# Technical Service Information

## FORD AXOD/AXOD-E FORWARD CLUTCH WAVE PLATE CHANGE

**FORWARD CLUTCH WAVE PLATE  
AXOD 1986 - 1988**

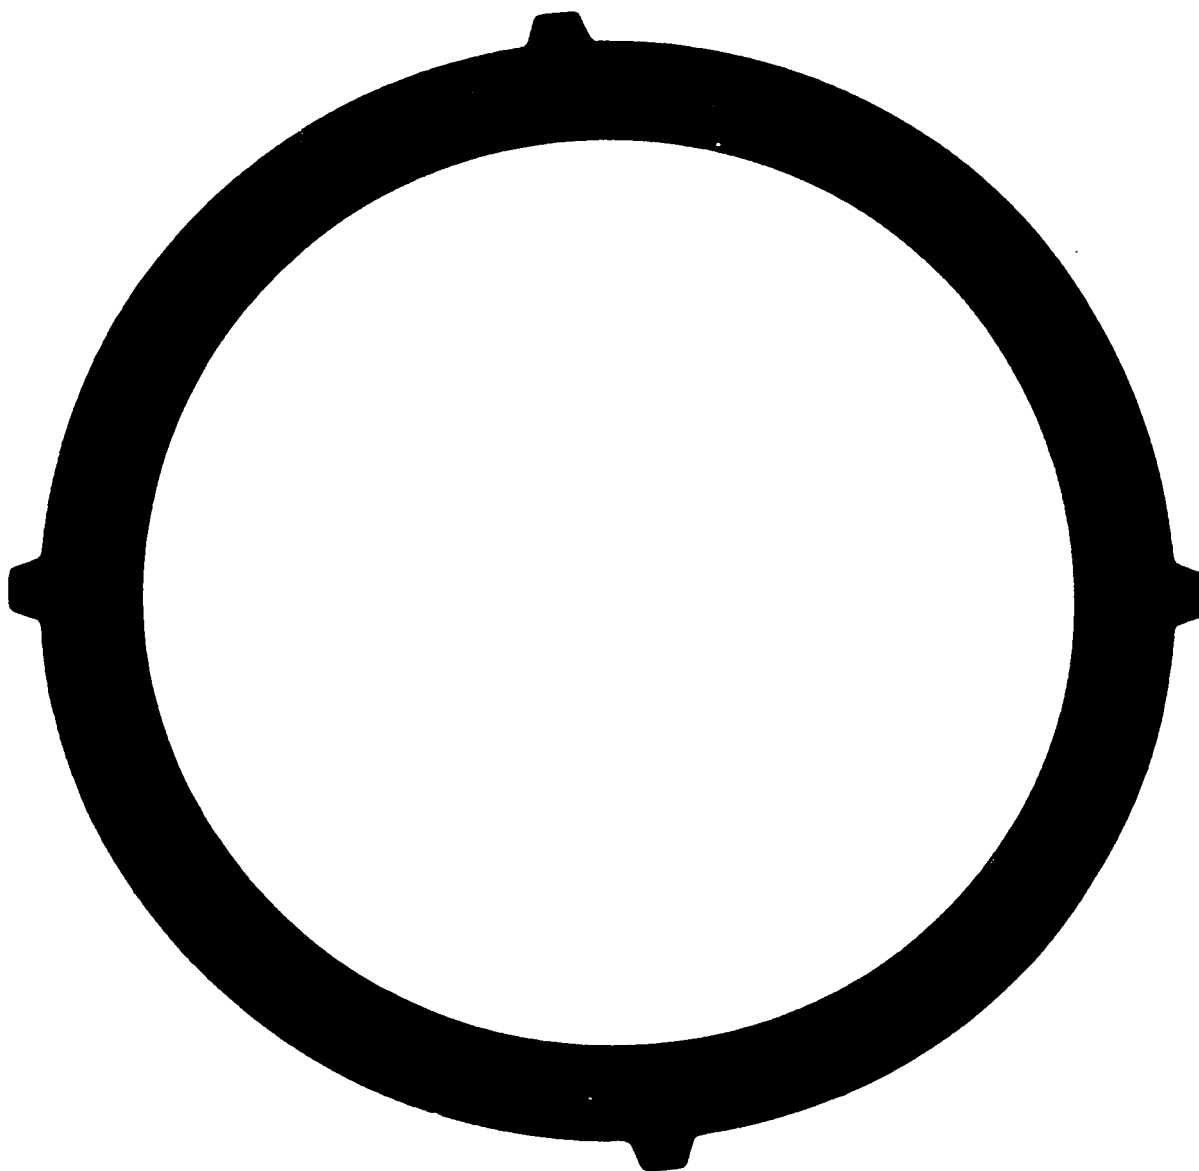
1ST DESIGN - Has 4 external teeth, an inside diameter of 4.715", material thickness of .062", and was used from 1986-1988. Refer to Figure 1.

**FORWARD CLUTCH WAVE PLATE  
AXOD 1989 - 1991**

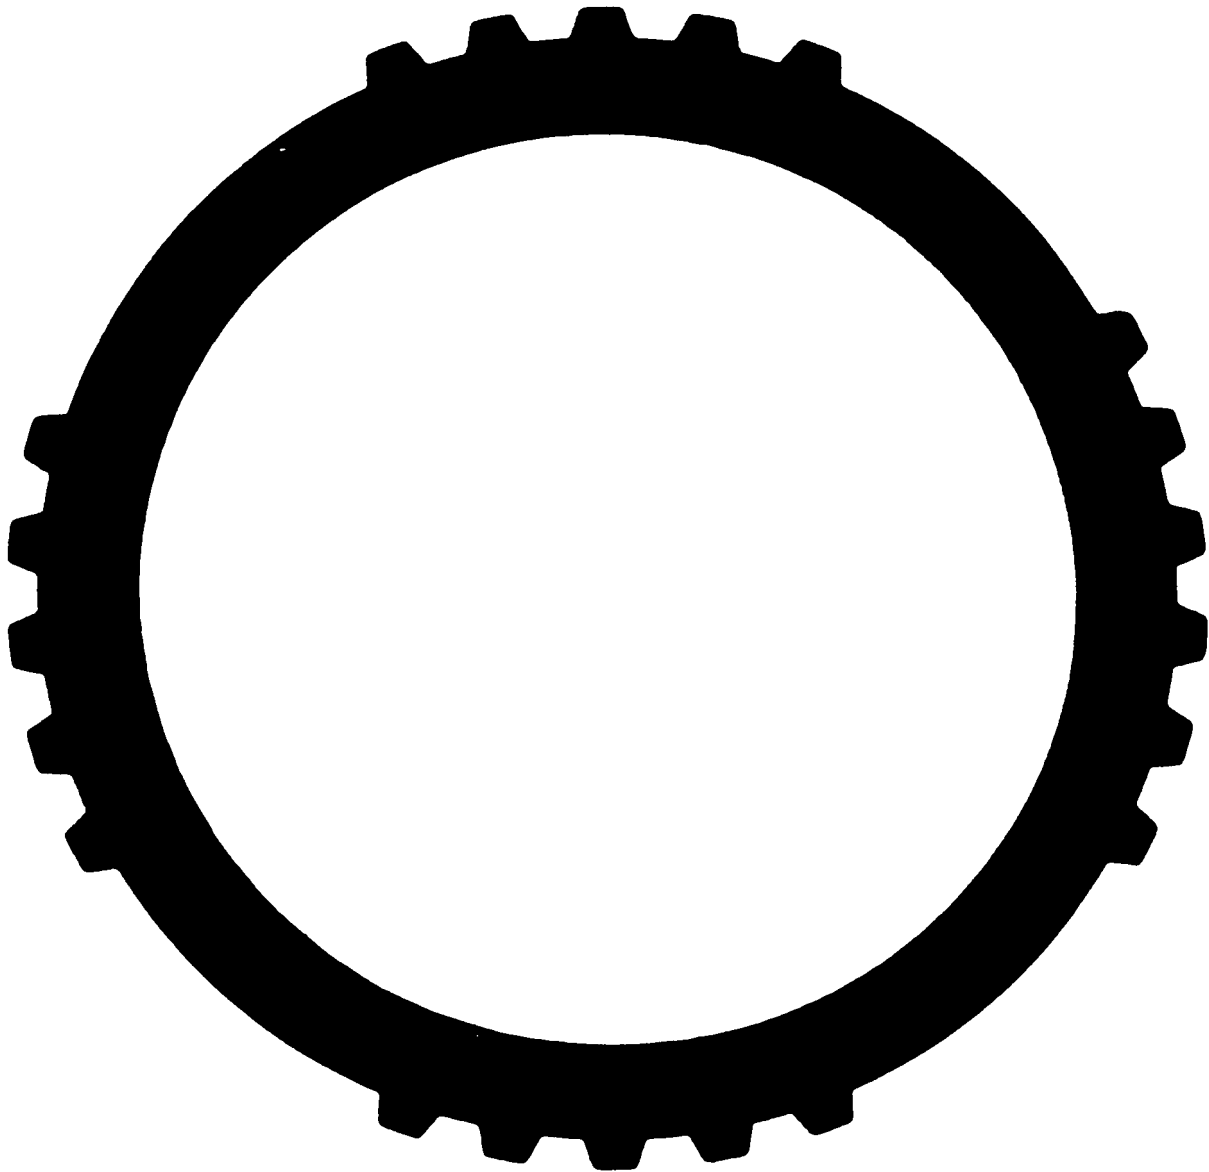
2ND DESIGN - Has 21 external teeth, an inside diameter of 4.730", material thickness of .075", identified with the letter "X" stamped on 1 tooth, and was used from 1989-1991 (See Figure 2).

The 2nd design forward clutch wave plate will retro-fit back to previous models and is the recommended wave plate for the AXOD.

**FORWARD CLUTCH WAVE PLATE  
AXOD 1992 - UP**

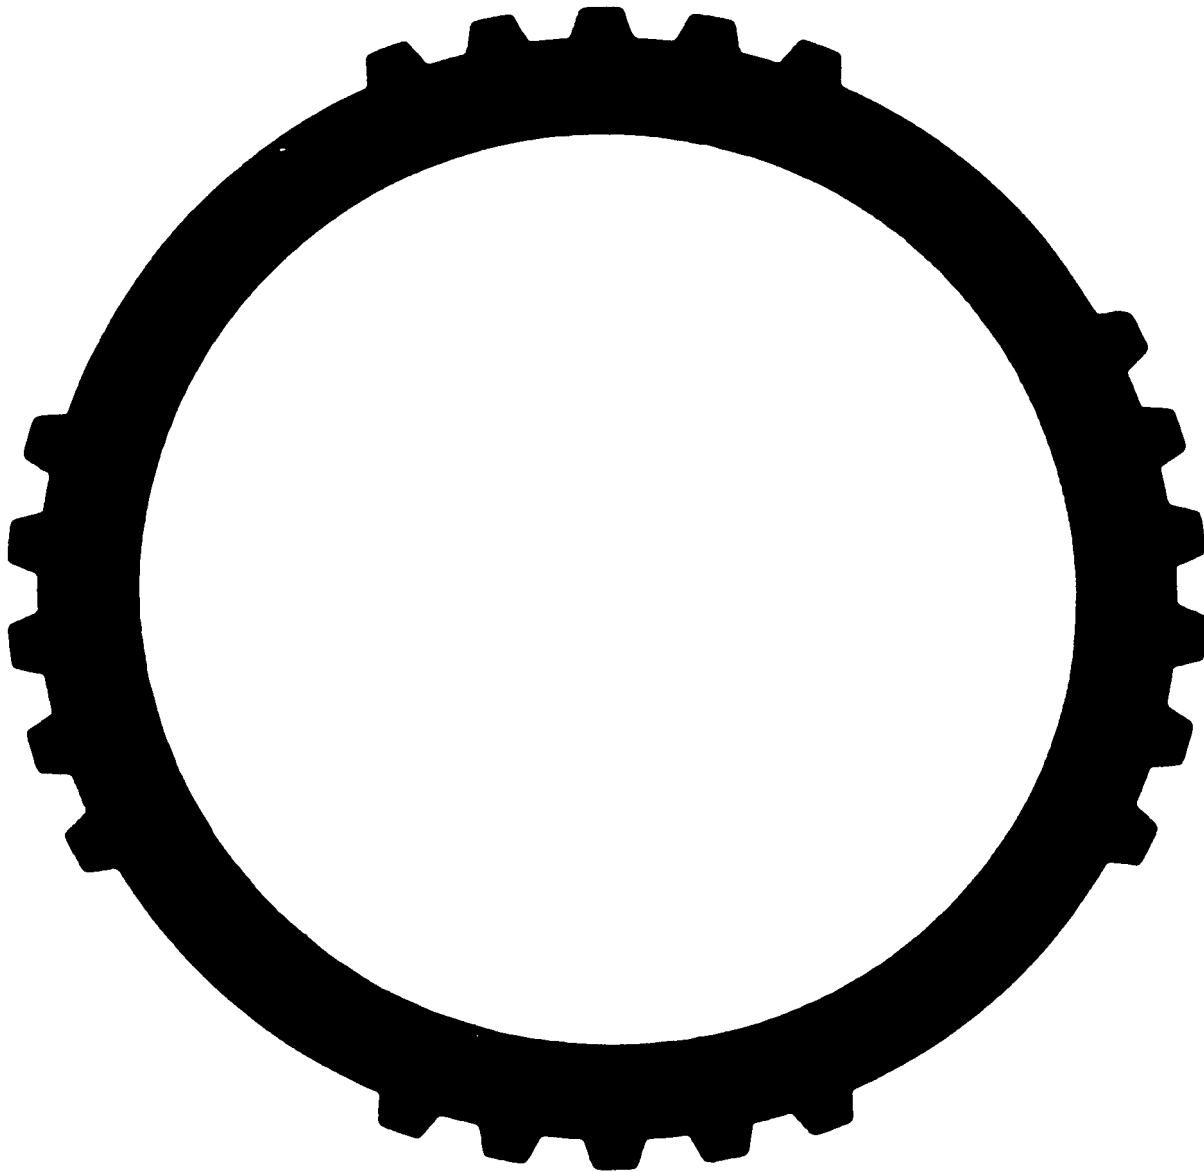
3RD DESIGN - Has 21 external teeth, an inside diameter of 4.930", material thickness of .083", identified with the letter "A" stamped on 1 tooth, and was used in 1992 and later models (See Figure 3).

The 3rd design forward clutch wave plate was associated with a change in the entire forward clutch pack and should be used ONLY on these models.
